UNITED STATES PATENT AND TRADEMARK OFFICE

APPLICATION NO.	FILING DATE	FIRST NAMED INVENTOR	ATTORNEY DOCKET NO.	CONFIRMATION NO.
10/628,349	07/29/2003	Chien-Chung Yeh	MR1683-484	4504

Office Action Summary

DETAILED ACTION

FIG. 1

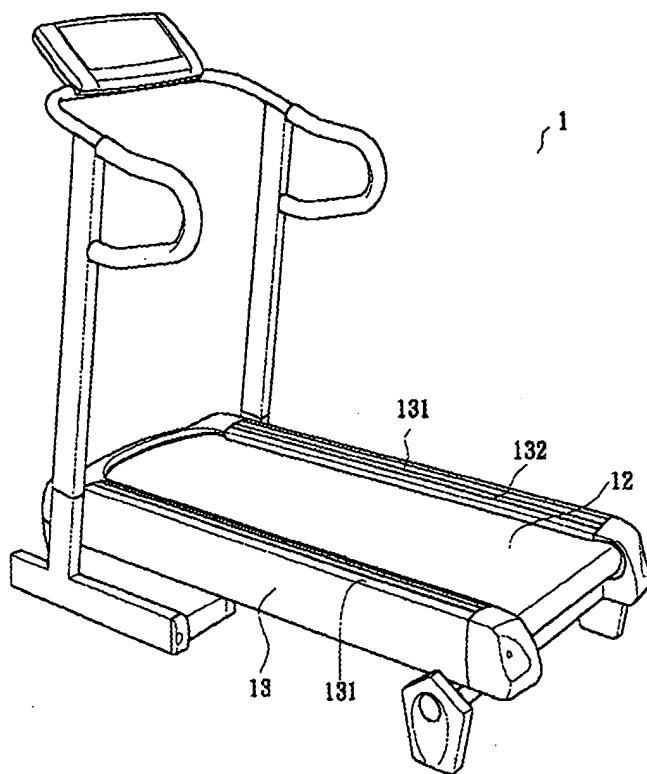
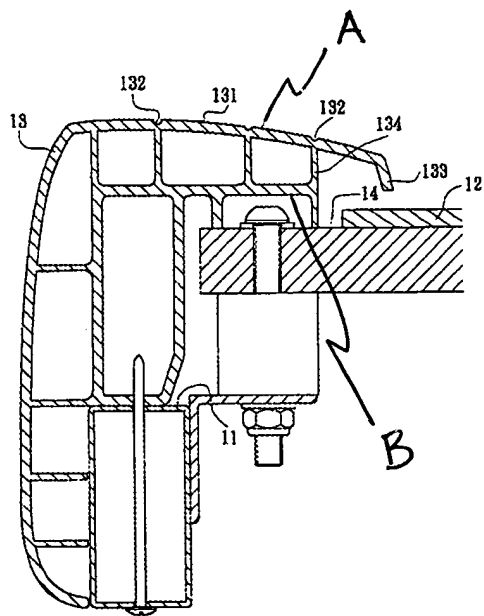
between and that the plastic members are made from blow-molding. Wu discloses a treadmill having step board plastic members (131) that include a top surface (A) and a bottom surface (B) with a buffering space there between for absorbing impact force (see Figs. 1 & 2 below), Wang et al. disclose a treadmill having a panel (70) that includes a buffering space between a top (71) and a bottom surface (73) (see Fig. 2) and Watterson et al. disclose a treadmill having frame components that are made by blow molding (see Col. 9, lines 10-27). At the time of the invention it would have been obvious to a person of ordinary skill in the art to combine the teachings of Wu, Wang and Watterson to make the PA's plastic step board and panel members via blow molding to have buffering spaces as substantially claimed to reduce the amount of raw material required and to decrease the overall weight of the structure to facilitate the transport and storage thereof.
